S E R V I C E B U L L E T I N

NO. FAS-020

1. SUBJECT : Establishment of drain hole.

2. AIRCRAFT AFFECTED : FA-200 Serial No. 1 through 85 airplanes.

Illustration of drain hole

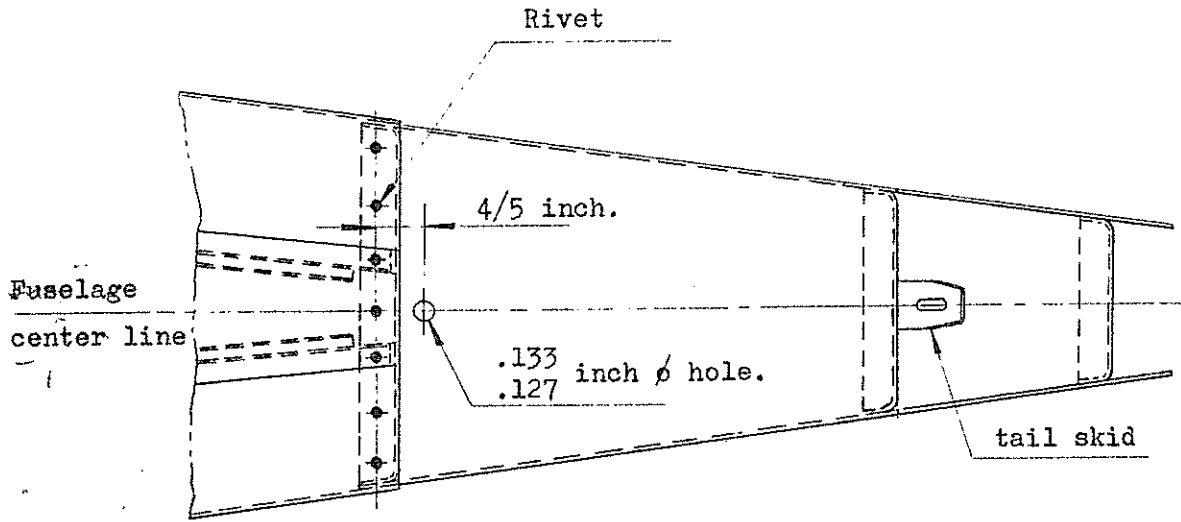
5. DESCRIPTION : Make drain holes on the wing tip pans (covers of aileron mass balance) and the fuselage tail cone.

13. WORK PROCEDURE : Make holes on the skin and tips as illustrated.
